MANNINGHAM

# LATE PAPER

### 9.1 Planning Application PLN20/0447 for Construction of a part six-storey, part seven-storey residential apartment building (containing 93 Dwellings) - at Tullamore 57 Stables Circuit, Doncaster

Figure 14: East Elevation (Plan Elevation TP-016)

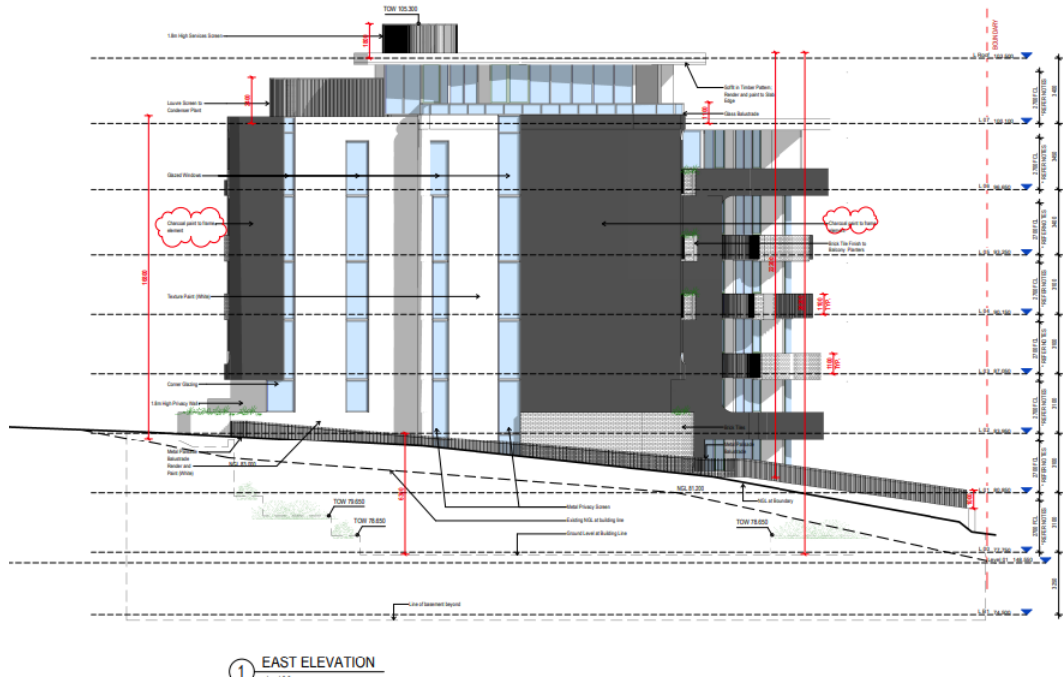
- 8.31 The design and building form however, presents five-storey sheer walls to the western and eastern elevations. As the plan elevations and Perspective views of each provided (Figures 14 to 17), both elevations offer minimal articulation and provide fenestration and material selection which exacerbates the verticality of these walls.

8.32 These sheer facades, with only vertical features, do not respond to the specific design principles of the Development Plan, which include to minimise sheer wall presentation, provide articulation and visual interest.

- 1.2. Additional visual interest provided to the eastern façade by providing:**
- a. Openings to the curve wall of the south-east corner balconies of Levels 3 to 6;**
  - b. Horizontal charcoal banding or similar to continue from the south-east balcony of Levels 6 and below where suitable; and**
  - c. A modified render colour or material (light grey bricks, render or textured surface) to the extent of the Level 6 eastern elevation, and/or alternative visual variation to the upper level charcoal sheer wall.**
